RE: Notice of Exhibition – New School - Minarah College (SSD 30759158)

**PROPERTY: 268-278 Catherine Fields Road, CATHERINE FIELD
LOT: 1001 DP: 1234527**

RE: Notice of Exhibition – New School - Minarah College (SSD 30759158)

Figure 1: Leppington Precinct- Indicative layout plan⁶ showing 5 possible locations for schools

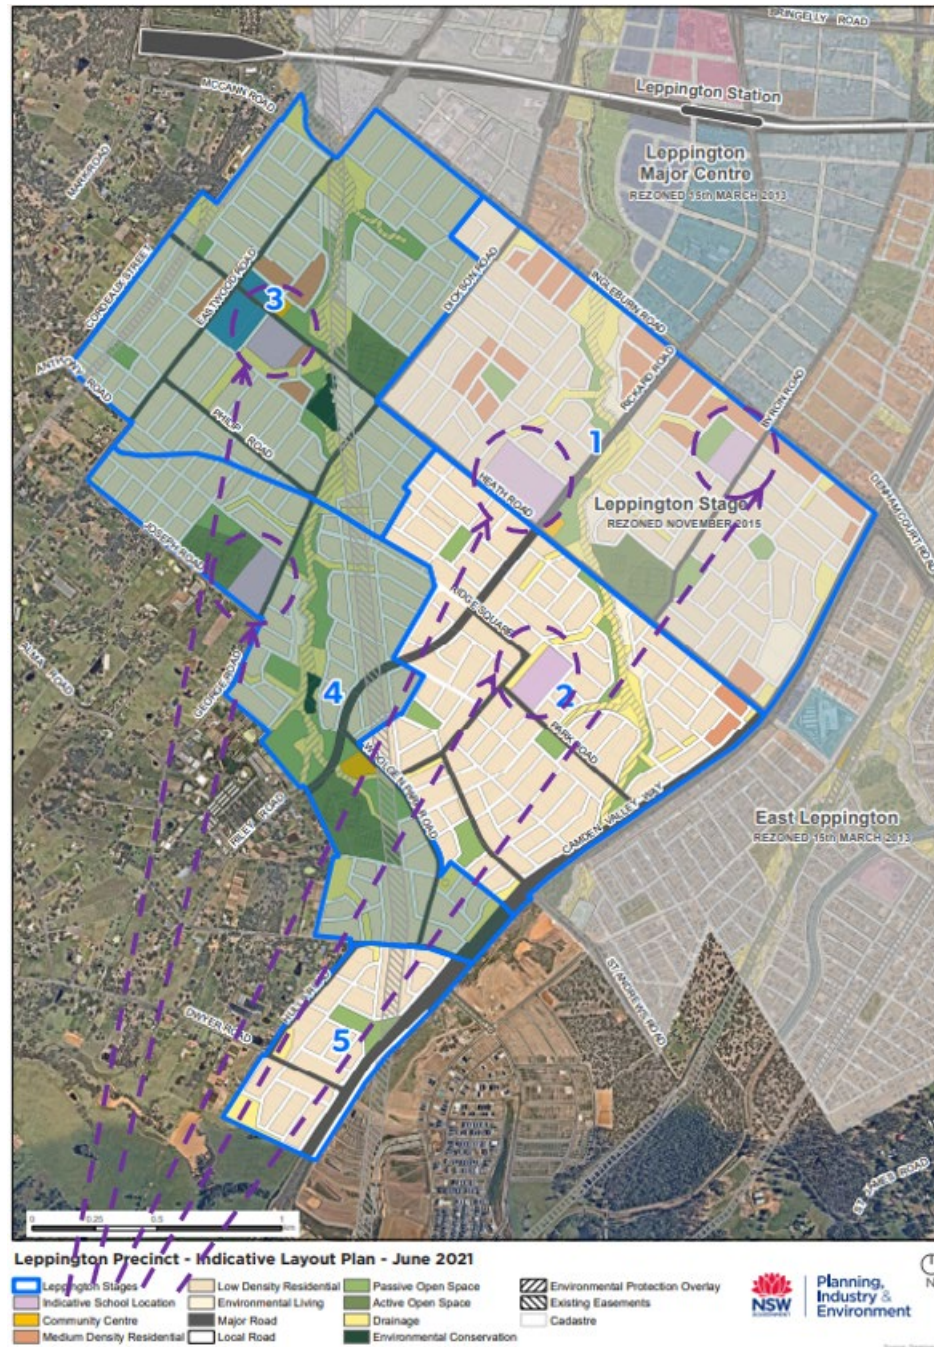
A scenario that has not been investigated is to locate the school in an area that has been rezoned where allotments for schools has already been provisioned. The Leppington⁵ precinct has plans for 5 school locations. Complete with services and a local plan that accommodates schools (for example, schools are located within walking distance of public sporting fields that can be utilized by schools and local

residents. See Figure below extracted from the Leppington Precinct indicative layout plan June 2021. The colored arrows show the location of 5 allotments which are named “indicative school locations”.

The development should seek a location that has plans for schools in their design, complete with infrastructure which will support the school and that the local community will benefit from.
